Final Reclamation Inspection- Overview

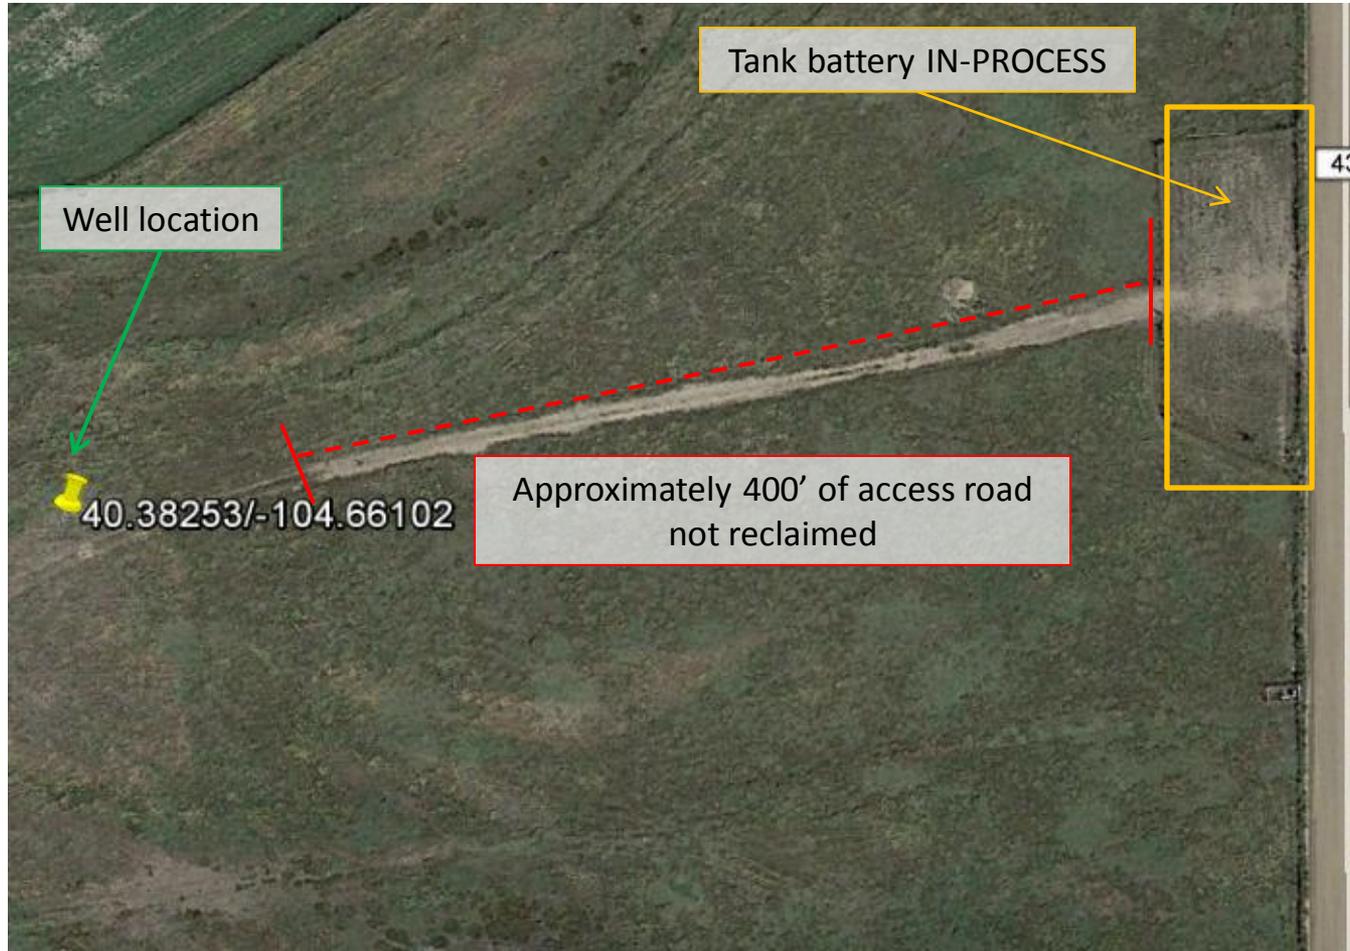
Google Earth aerial photo taken 9/7/2016 illustrating total extent of disturbance. Well location passes Rule 1004 standards. Tank battery location IN-PROCESS. Appears that approximately 400' of the access road has not been reclaimed.
